FINAL PLAT OF
YMCA SOUTH ADDITION
AN ADDITION TO WICHITA, SEDGWICK COUNTY, KANSAS

Re: S/D 98-15 -- Final Plat of YMCA SOUTH ADDITION

CASE NUMBER: S/D 98-15 - YMCA SOUTH ADDITION

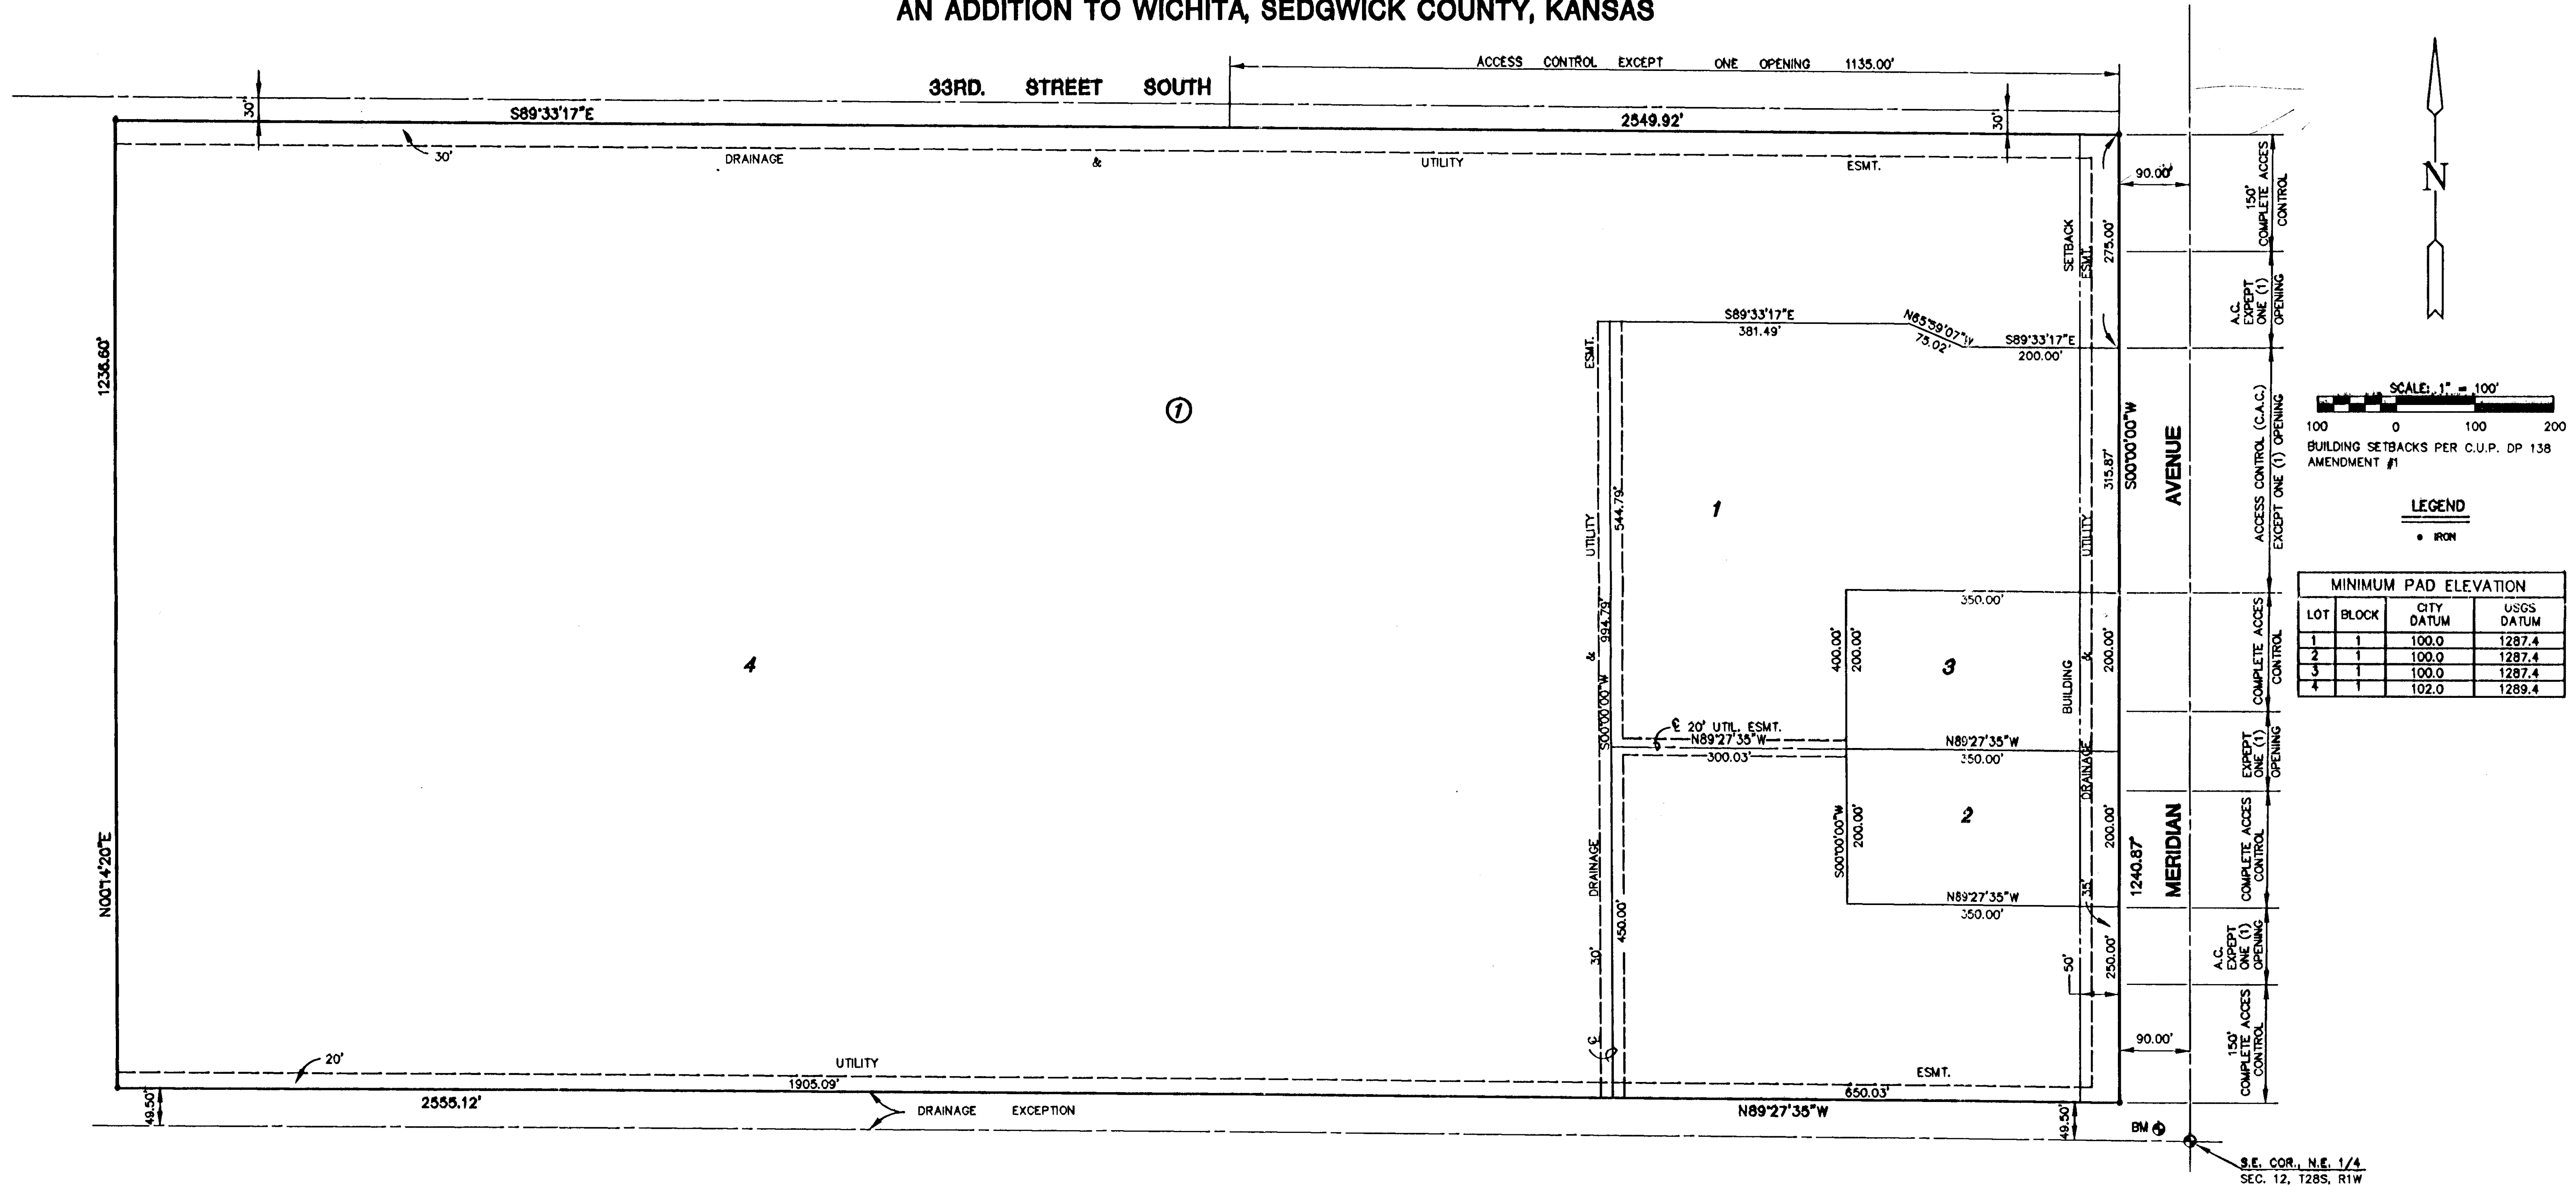
- D. The plat does not conform with the access controls approved for the CUP. The plat denotes five openings along Meridian; whereas the CUP restricted the site to four openings. The CUP also required a joint access between lots 1 and 2. The joint access easement will need to be established by separate instrument. Initial construction responsibilities and future maintenance of the driveway within the easement should also be addressed by the text of the instrument. Four openings, in conformance with the CUP, are required. Joint access between lots 2 and 3 will be needed - and an adjustment to the CUP will have to be made. Complete access control shall be required along the northern 150 feet of the northern lot (lot 4). Complete access control is required along the southern 150 feet of the southern lot (lot 1).

- E. ☒ On the final plat tracing, the platlor's text shall specifically note that the access controls are being dedicated to the City of Wichita.

- G. As required by the CUP, the applicant shall guarantee paving of the south half of 33rd Street South from Meridian to Gordon. Traffic Engineering needs to comment on the need for improvements to Meridian. A decel lane for the driveway to lot 4 is required. Decel lanes for other lots may be required when development plans are finalized by the applicant.

☒ The final plat denotes four openings along Meridian and a joint access between lots 2 and 3 in accordance with the above requirements.
